Invitation for Bid No. 2024-030

Twelve Mile Creek WRF 9.0 mgd Expansion

ADDENDUM No. 1 **ISSUE DATE: July 25, 2024**

ADDENDUM NO. 1 TO CONTRACT DOCUMENTS

DATE:	JUNE 2024
HAZEN NO.:	30831-061
CONTRACT NO.:	1
DRAWING NUMBER:	M110

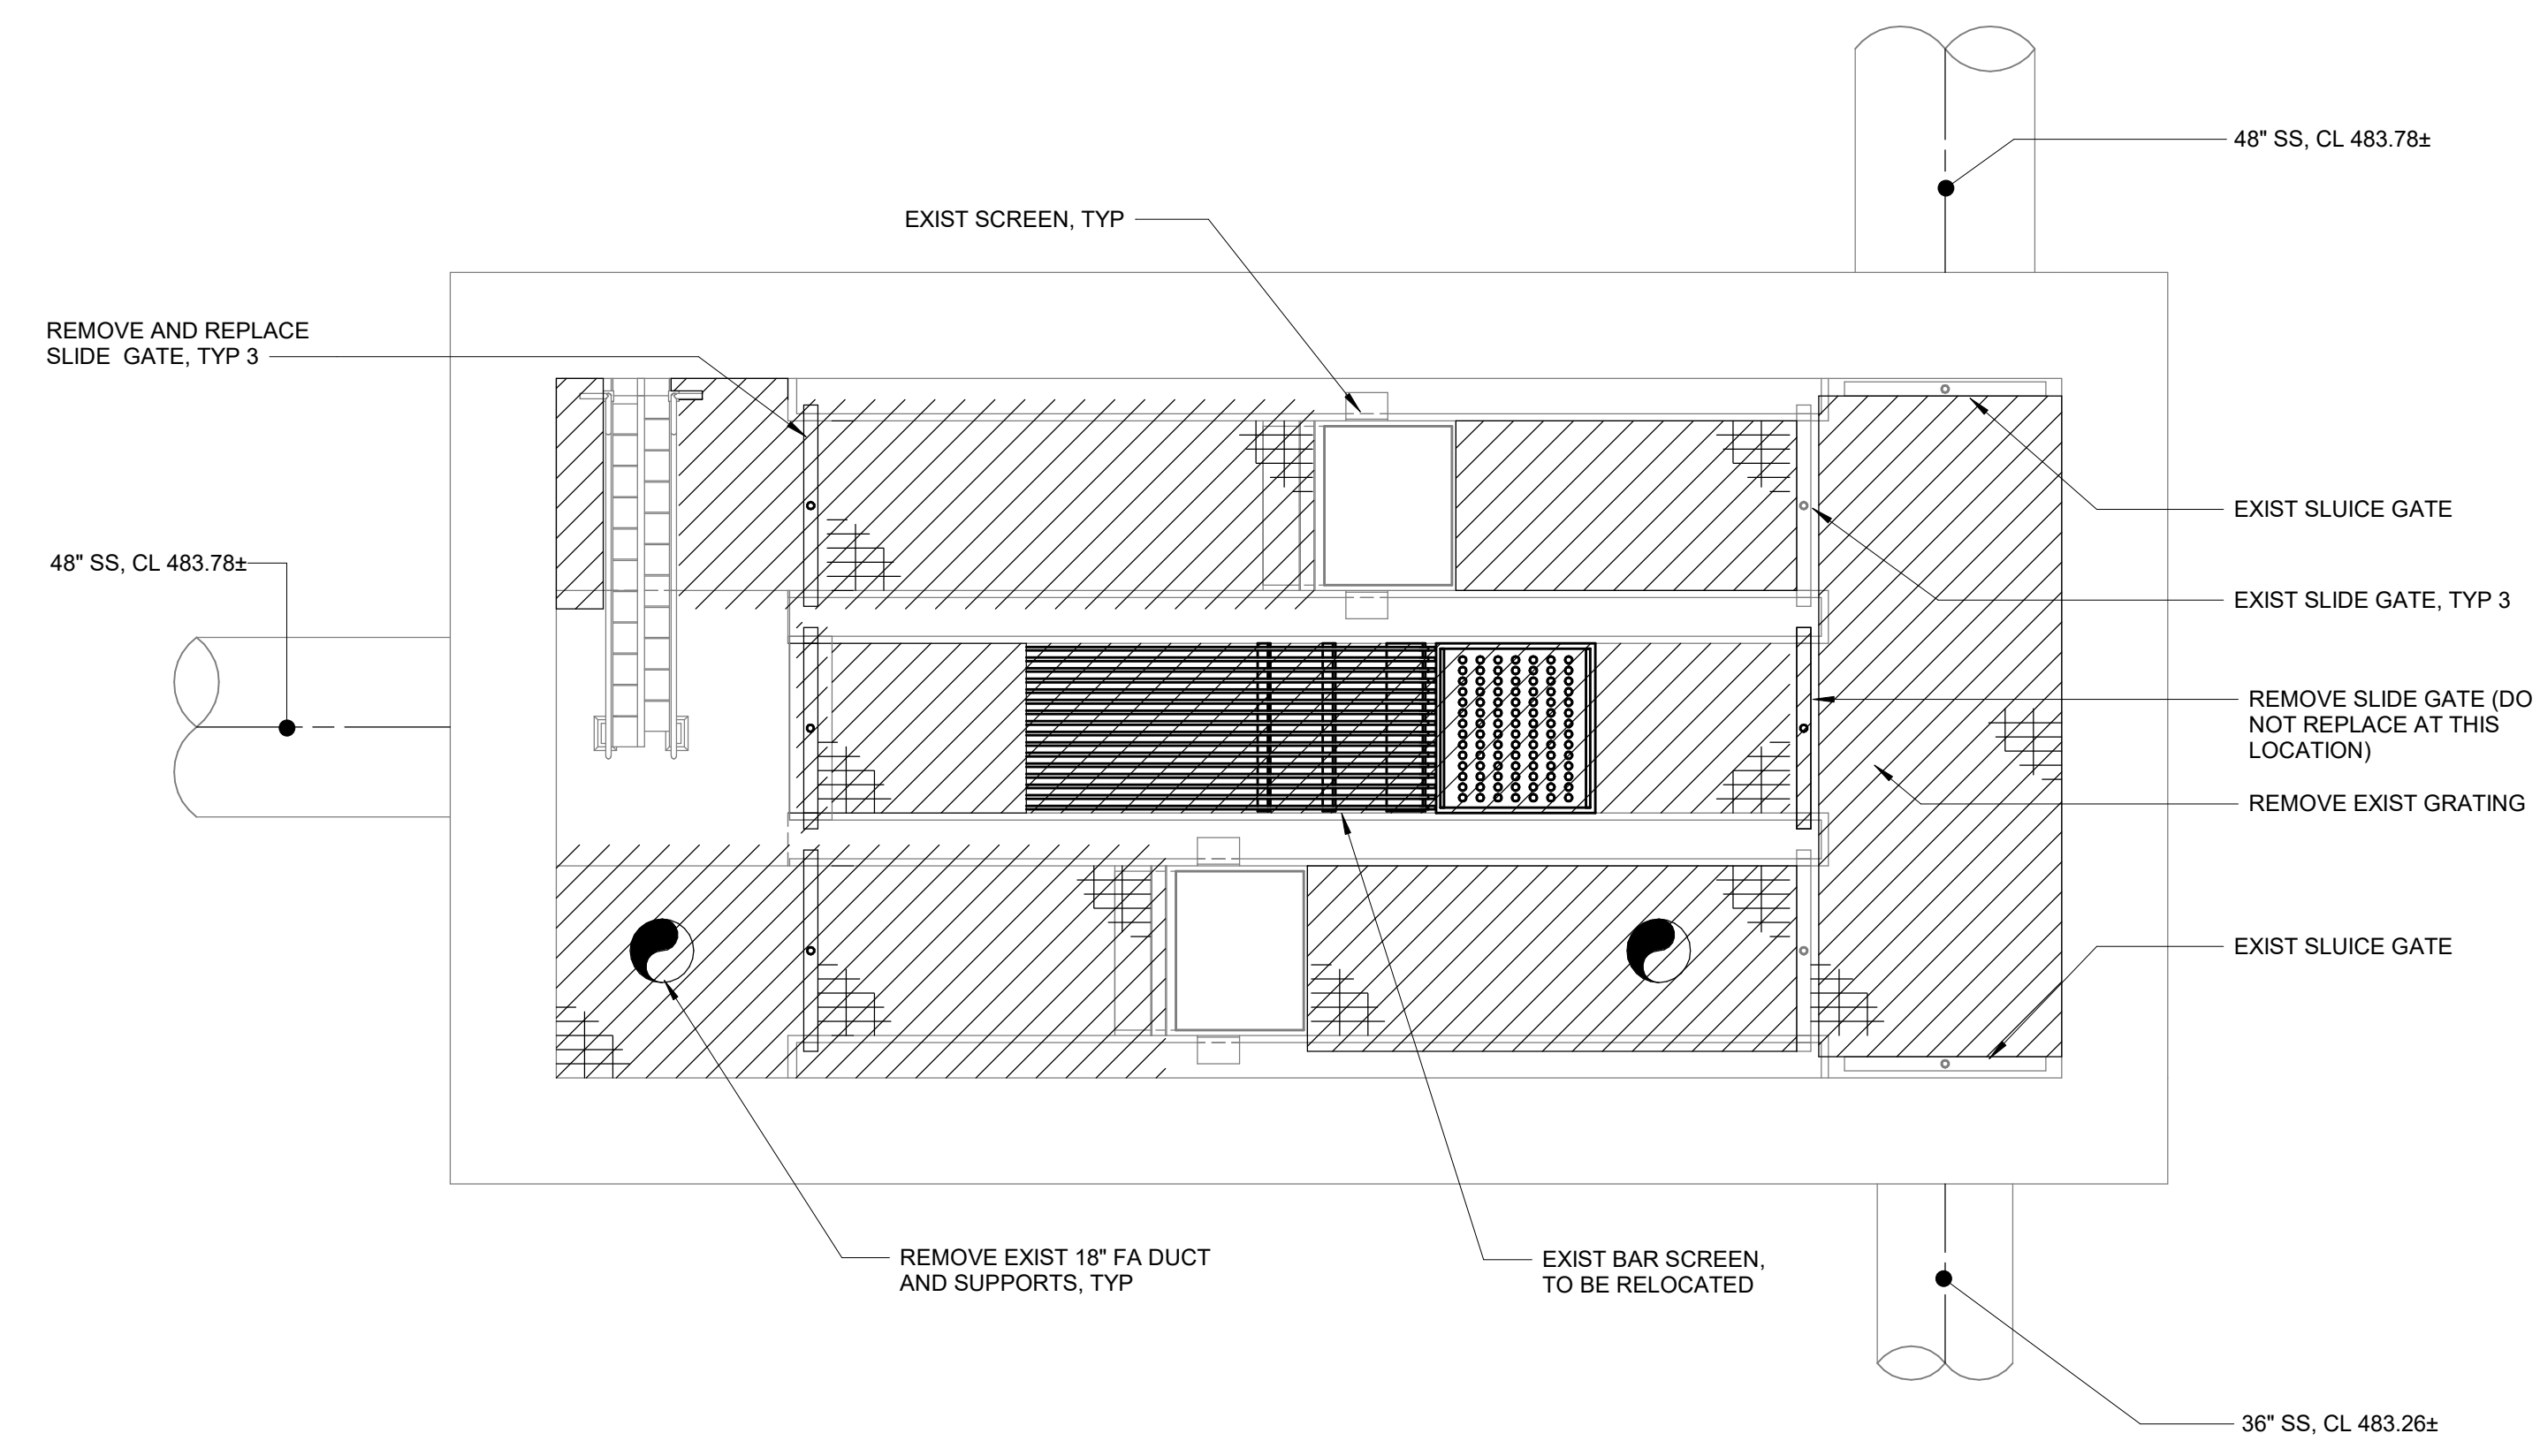
DRAWINGS M110 – M114

Replace drawings with the attached drawings.

- Approximately 40 linear feet of existing odor ductwork and supports shown to be demolished.
- Existing grating shown to be demolished.
- New grating shown to be installed.

DATE:	JUNE 2024
HAZEN NO.:	30831-061
CONTRACT NO.:	1
DRAWING NUMBER:	M111

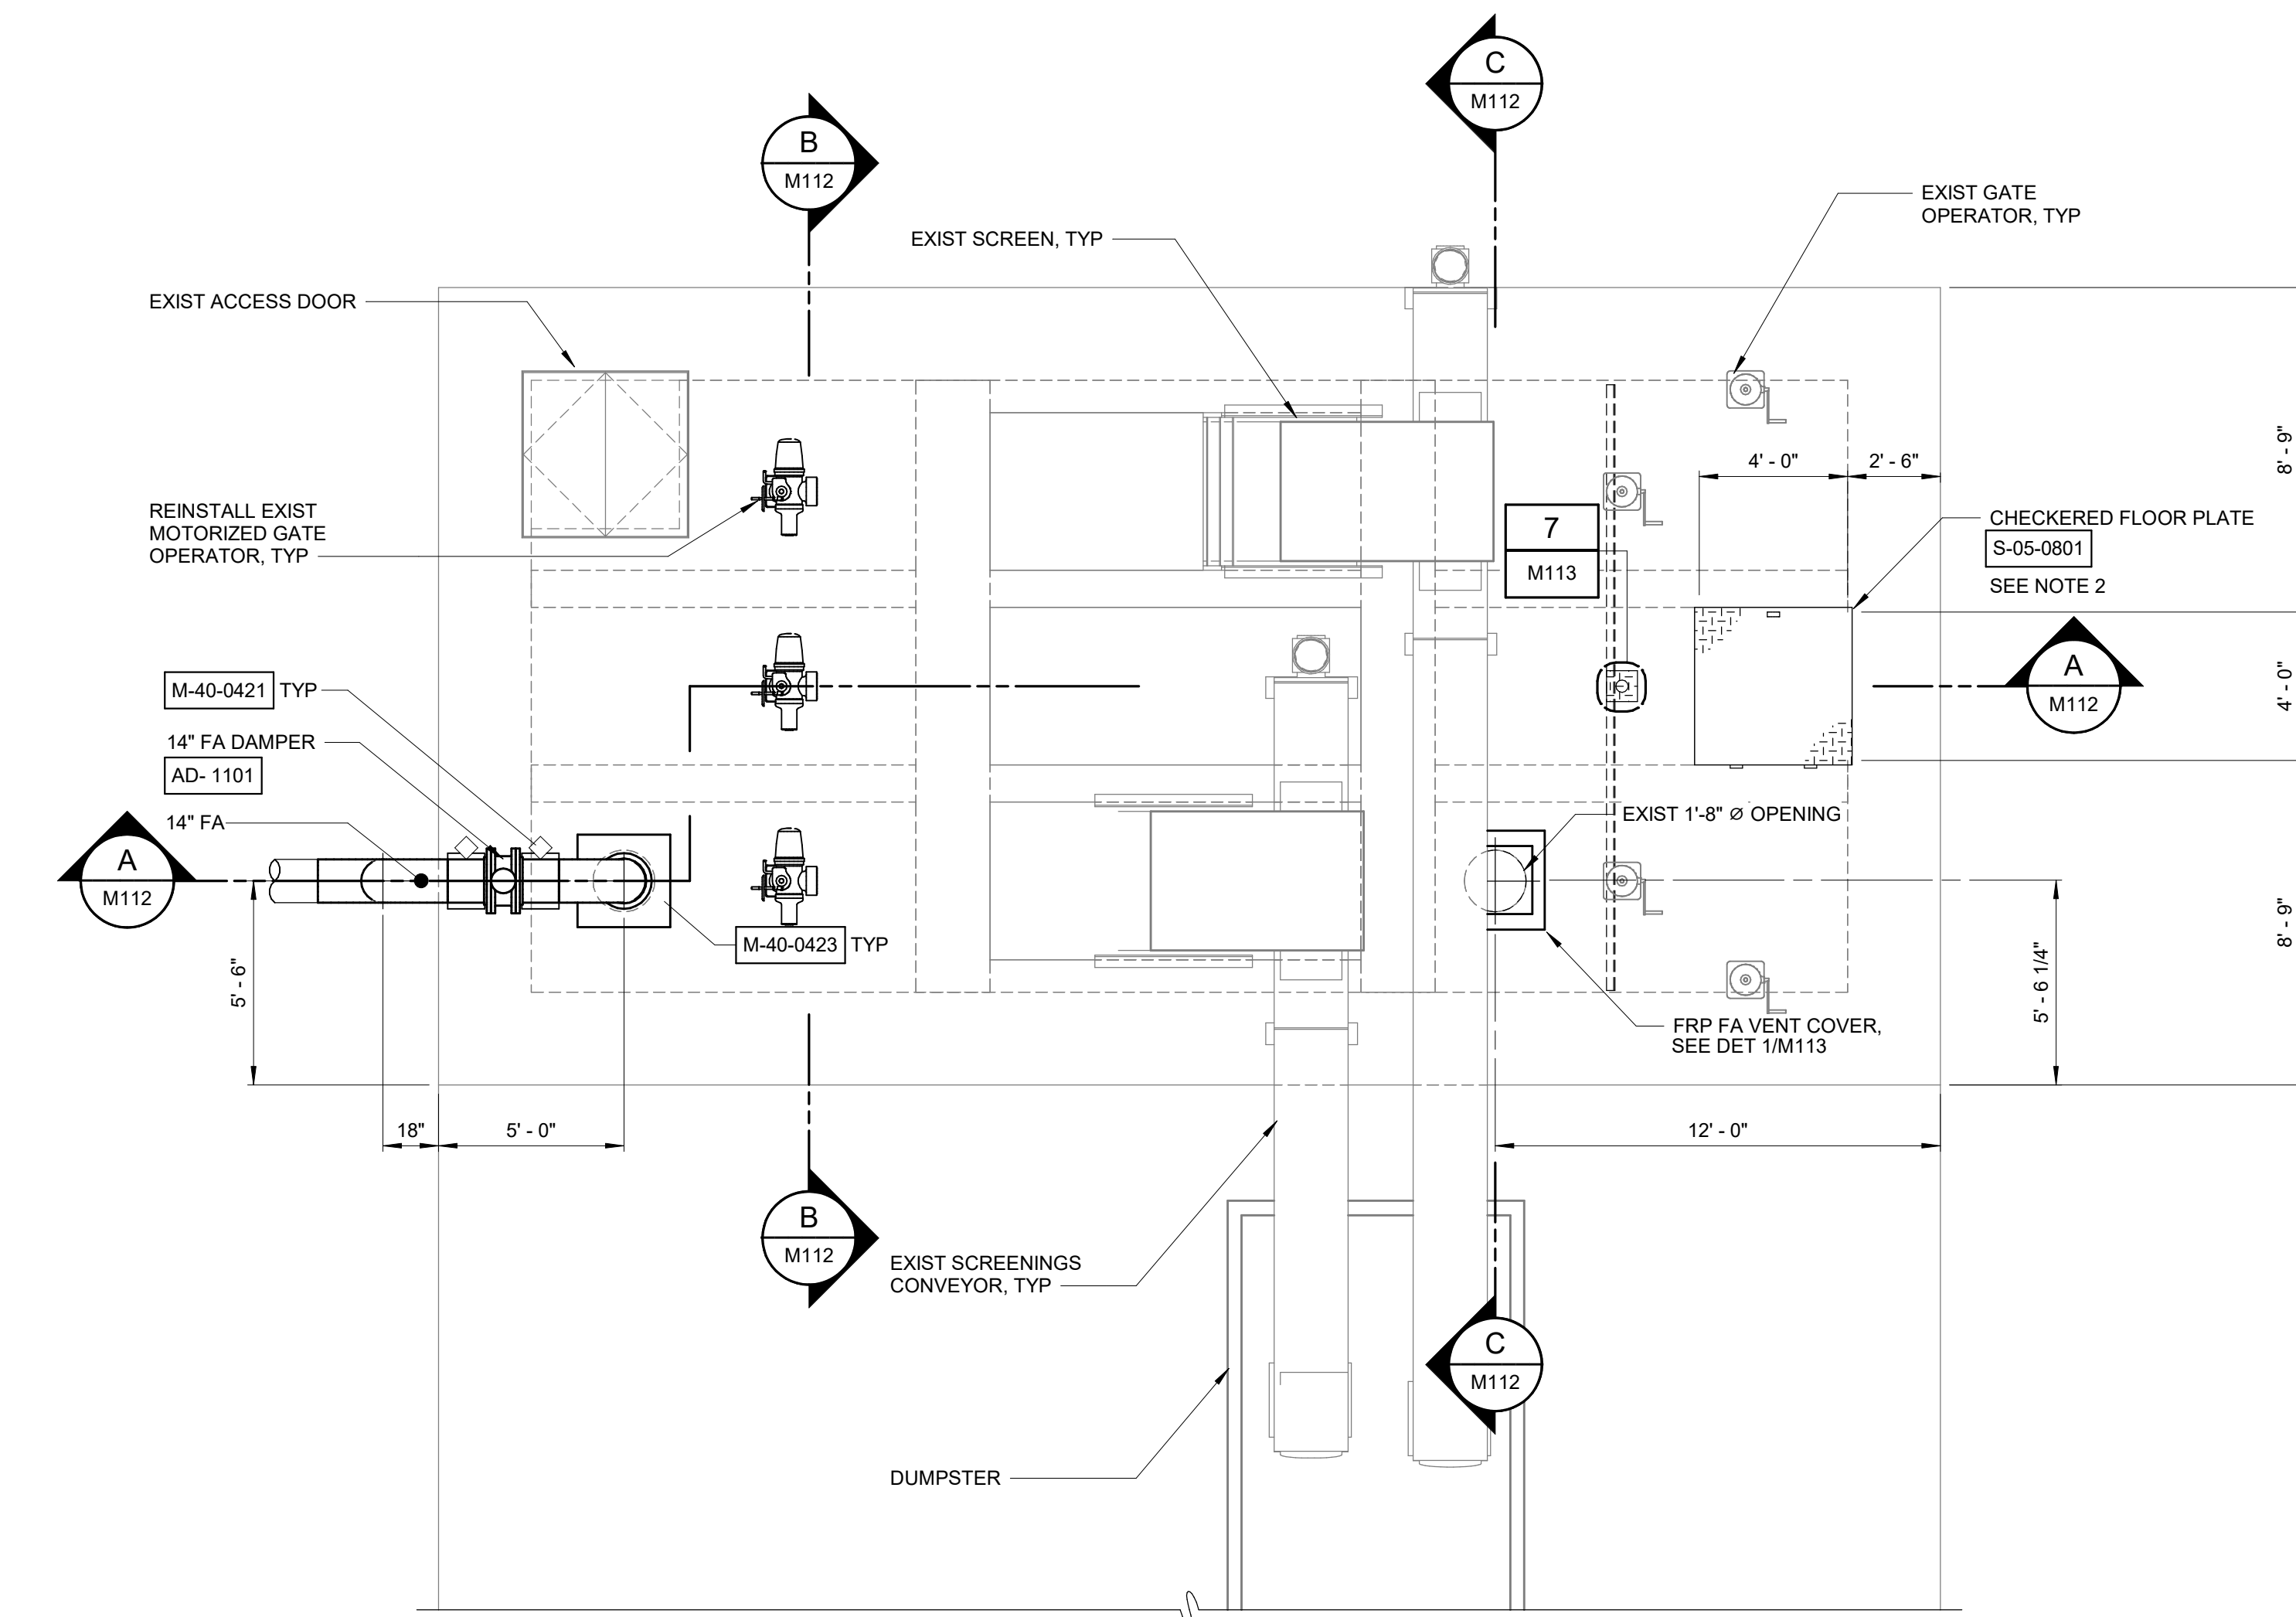
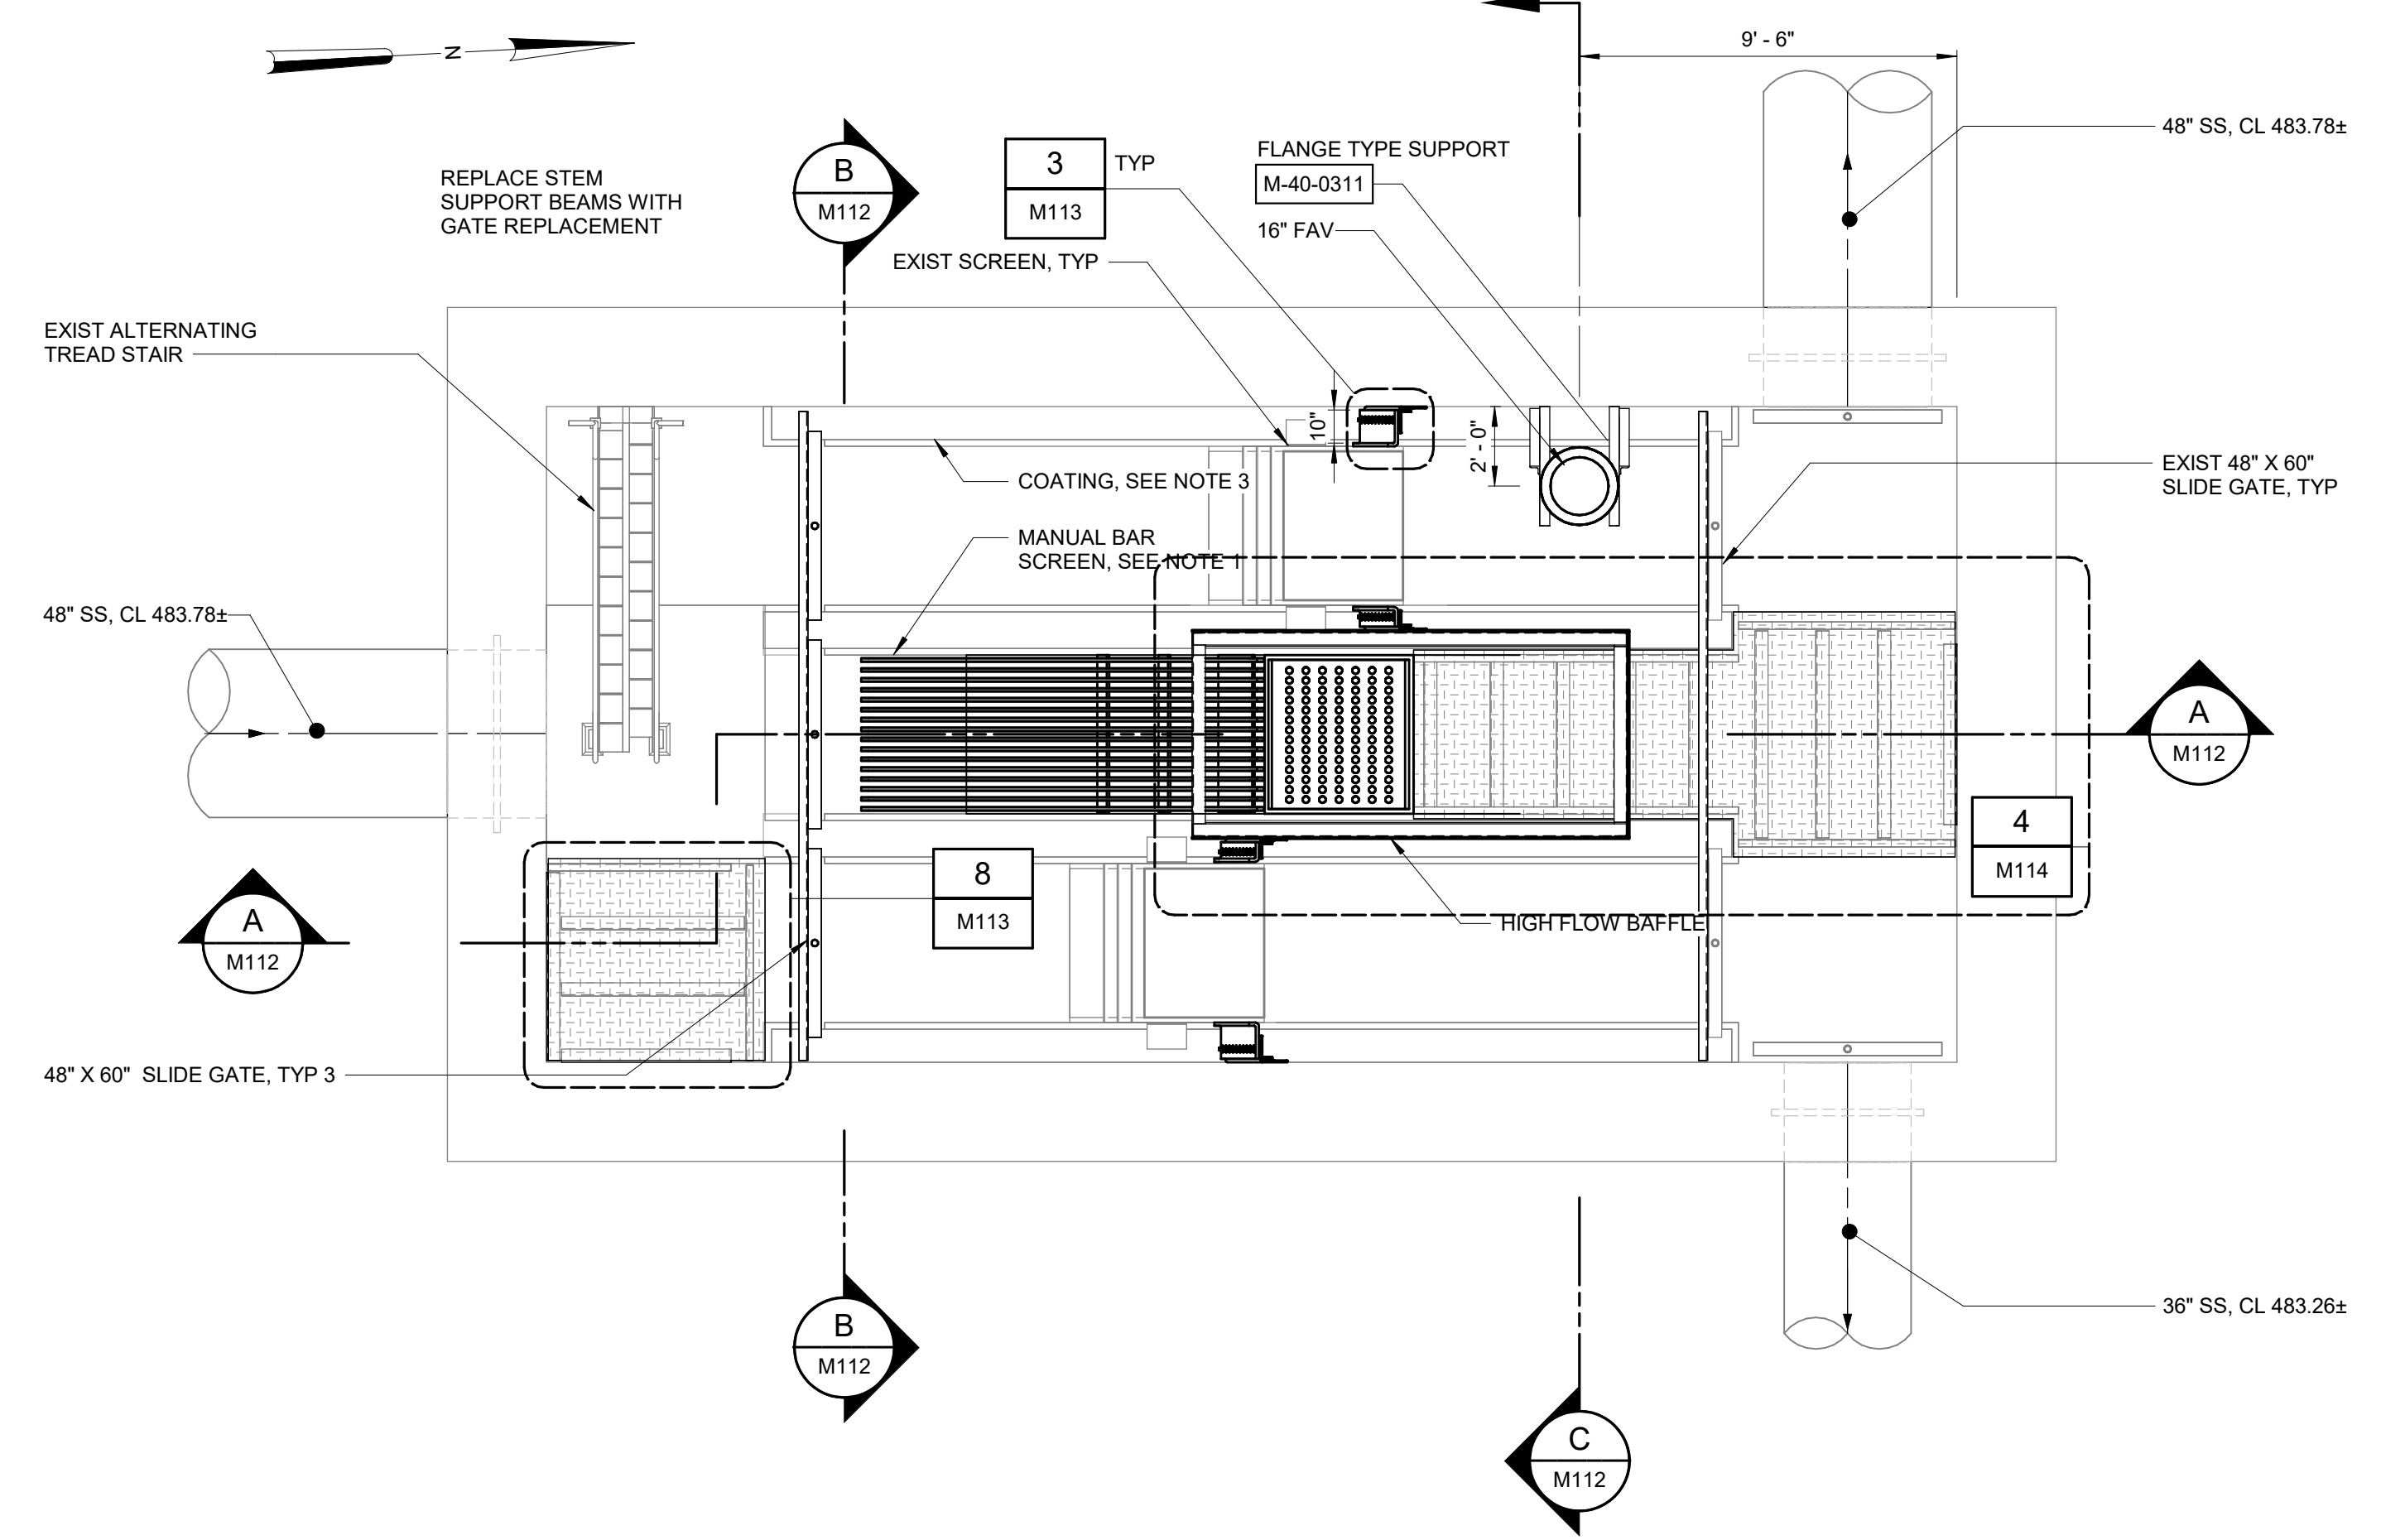
- Gate stem support beams shown to be replaced.
- Note 3 added on M111.]
